# UNITED STATES PATENT AND TRADEMARK OFFICE

APPLICATION NO.	FILING DATE	FIRST NAMED INVENTOR	ATTORNEY DOCKET NO.	CONFIRMATION NO.
09/837,934	04/19/2001	Garry Van Houten	LII161A US	8324
21133	7590	10/22/2003	EXAMINER	
VAN OPHEM & VANOPHEM, PC 51543 VAN DYKE SUITE 103 SHELBY TOWNSHIP, MI 48317-4447			STORMER, RUSSELL D	
			ART UNIT	PAPER NUMBER
			3617

# Office Action Summary

See figure 3 of Kinstler reproduced below with the additions of radial and axial direction indicators.

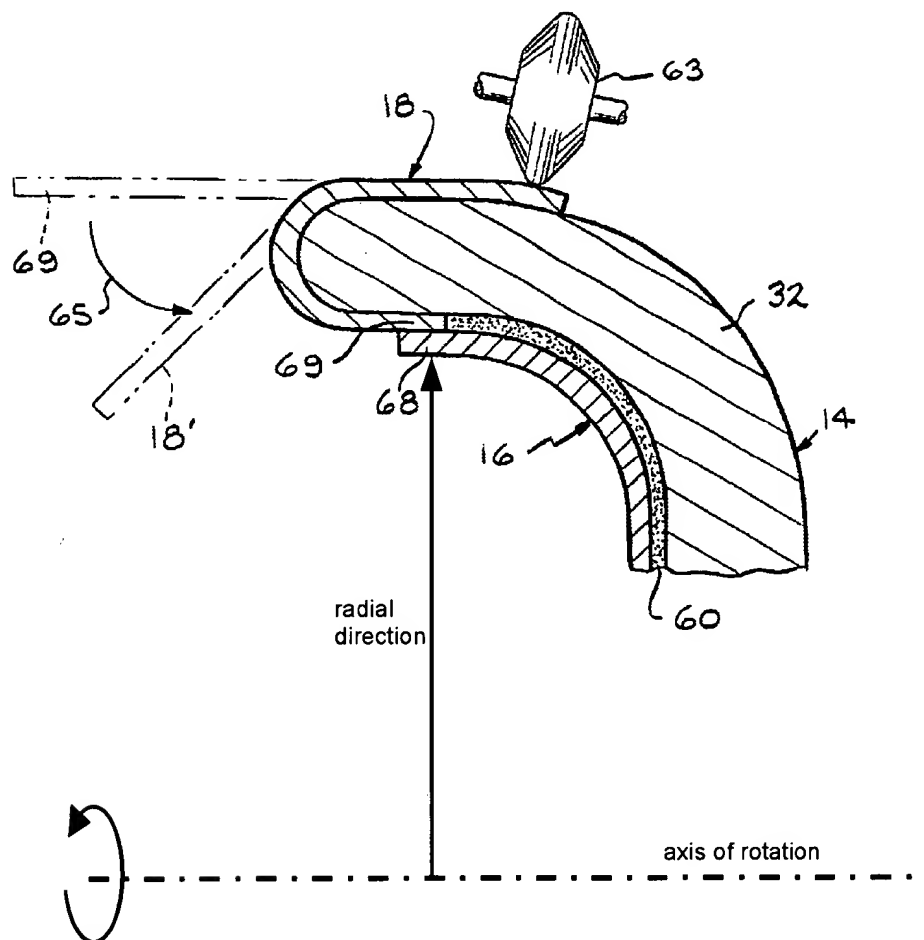
Kinstler clearly shows a portion of the trim ring overlapping the radially outermost periphery of the cladding in a radial direction. See any of figures 2-8. As shown in figure 3, for instance, a line extending in a radial direction from the axis of the wheel assembly will pass through both the trim ring and the cladding.

It is therefore not understood how Applicants can argue that the cladding of Kinstler does not overlap the trim ring in a radial direction.
